To: Planning Committee

File: RZ 13-638387

Re: **Application by Konic Development Ltd. for Rezoning at 7151 No. 2 Road from Single Detached (RS1/E) to Low Density Townhouses (RTL4)**

Staff Report

Tree Retention & Removal Plan, Scale 1/16" = 1'

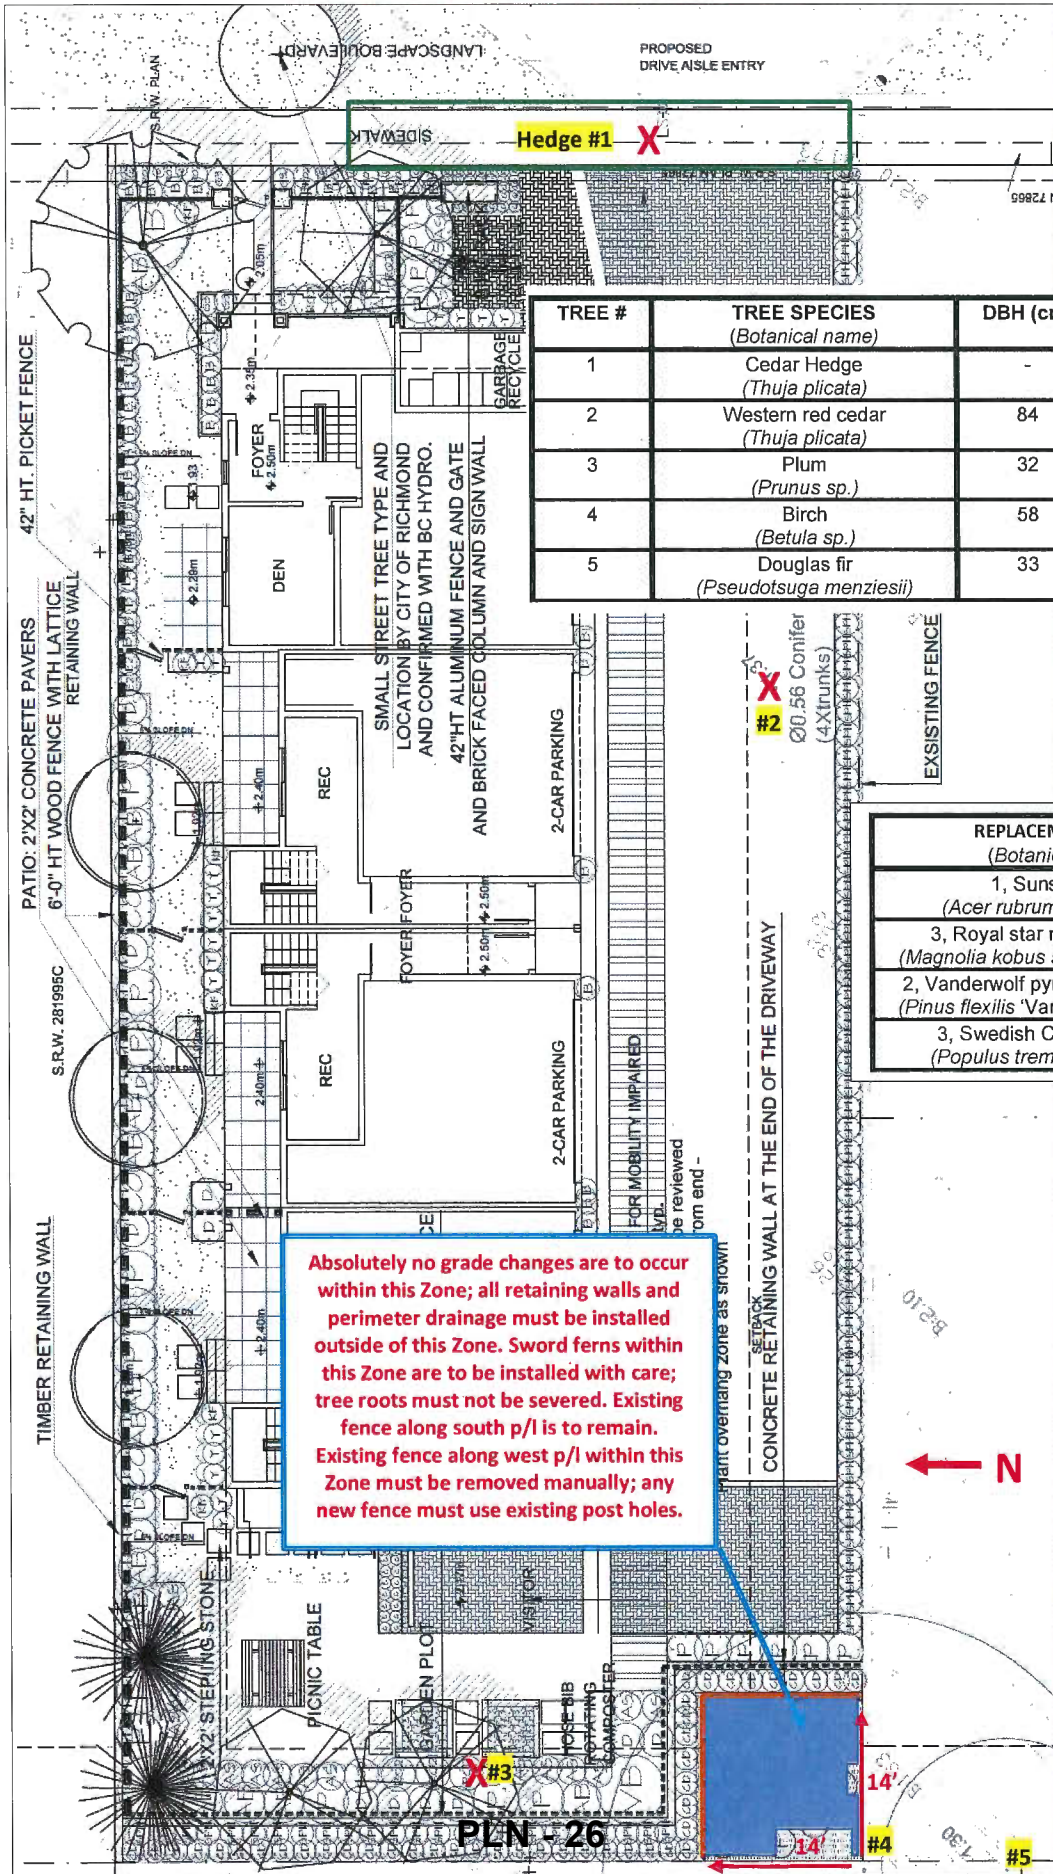
The applicant has submitted a Certified Arborist's Report, which assesses tree structure and condition, and provides recommendations on tree retention and removal. The report assesses two bylaw-sized trees on the subject property, a cedar hedge along the east property line of the site, and two trees on neighbouring properties to the southwest. The City's Tree Preservation Coordinator and Parks Operations staff have reviewed the Arborist's Report and accepted the proposed tree retention scheme (Attachment 4) with the following comments:

- One Western Red Cedar tree (tag# 2) and one Plum tree (tag# 3) located on the development site are infected with Fungal Blight and have been previously topped. As a result, these trees are not good candidates for retention and should be removed and replaced.

- One Birch tree (tag #4) and one Douglas Fir tree (tag #5) located on the adjacent property to the west are identified to be retained and protected. Provide tree protection as per City of Richmond Tree Protection Information Bulletin Tree-03.

- Replacement trees should be specified at 2:1 ratio as per the OCP.
- One cedar hedge on city's boulevard along the east property line of the site will be in conflicts with proposed vehicle access. Parks Operations staff agreed to the proposed removal based on the health and condition of the trees, as well as the required frontage improvement works along No. 2 Road. No compensation is required.

The applicant wishes to remove two on-site trees (tag# 2 & 3). The 2:1 replacement ratio would require a total of four replacement trees. According to the Preliminary Landscape Plan provided by the applicant (Attachment 2), the developer is proposing to plant nine new trees on-site. The size and species of replacement trees will be reviewed in detail through Development Permit and overall landscape design.

Two trees (tag # 4 & 5) on the neighbouring property at to the west are to be retained and protected. To ensure that the trees identified for retention are protected at development stage, the applicant is required to complete the following items:
